INFO-TECH CITROËN Racing C3R5 20-15**Sujet: Powerbox**

Subject:

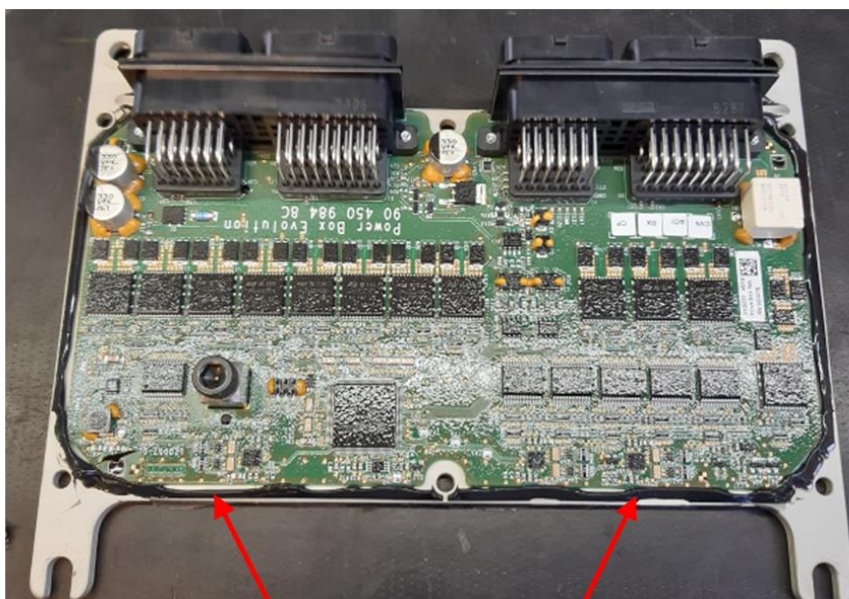
Afin d'améliorer la fiabilité de votre C3R5 et plus particulièrement celle de la powerbox, nous vous recommandons de réaliser un joint de silicone ou CAF entre les 2 parties du boîtier comme illustré sur les photos suivantes :

- Retirer les 6 vis torx,

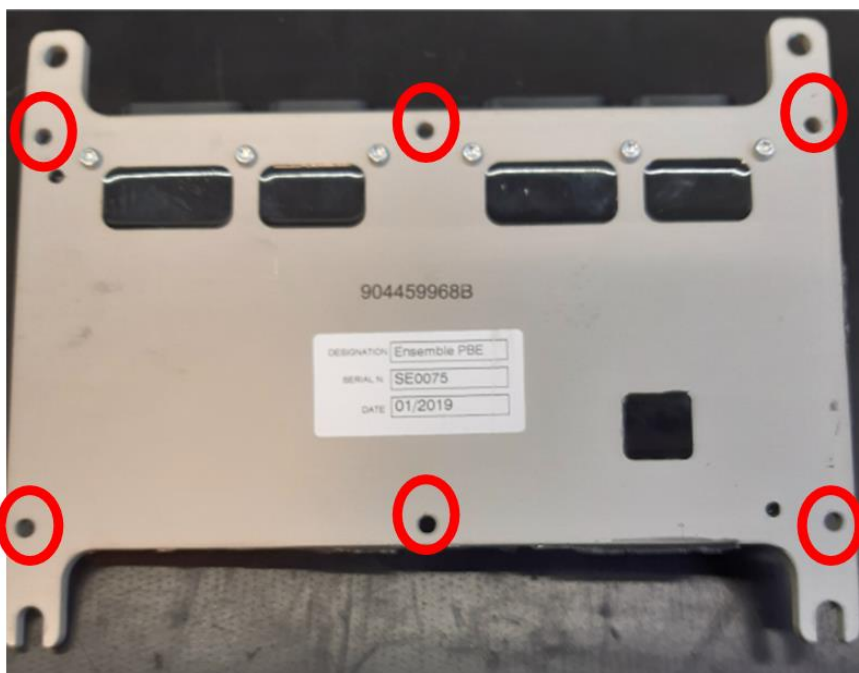
- Réaliser un joint silicone sur tout le pourtour du châssis,

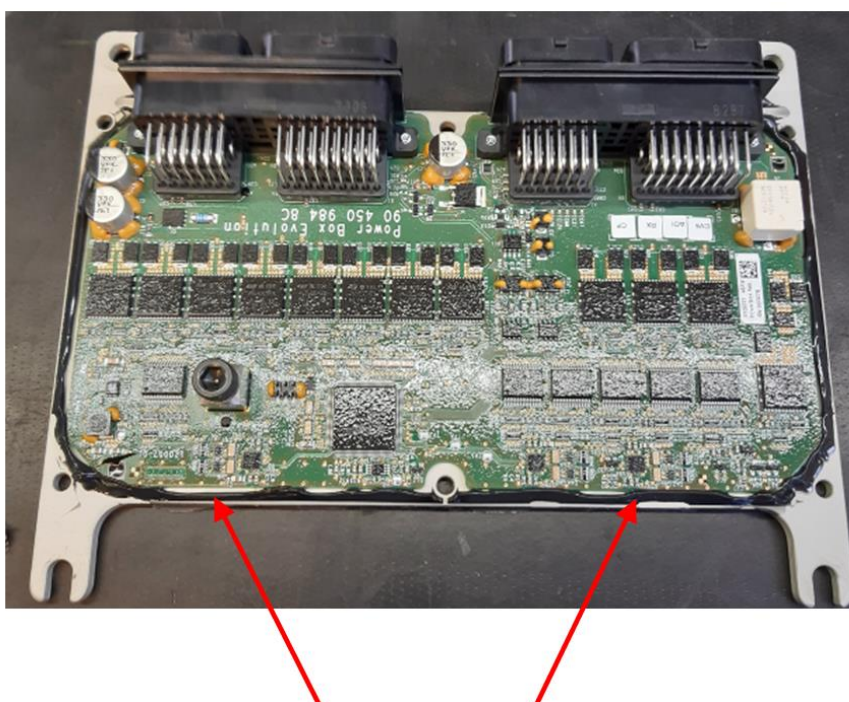
In order to improve the reliability of your C3R5 and more precisely of the powerbox, we advise you to add a silicone seal between the 2 parts of the housing as described below:

- Remove the 6 screws,

- Add a silicone seal all around the chassis to ensure proofness,
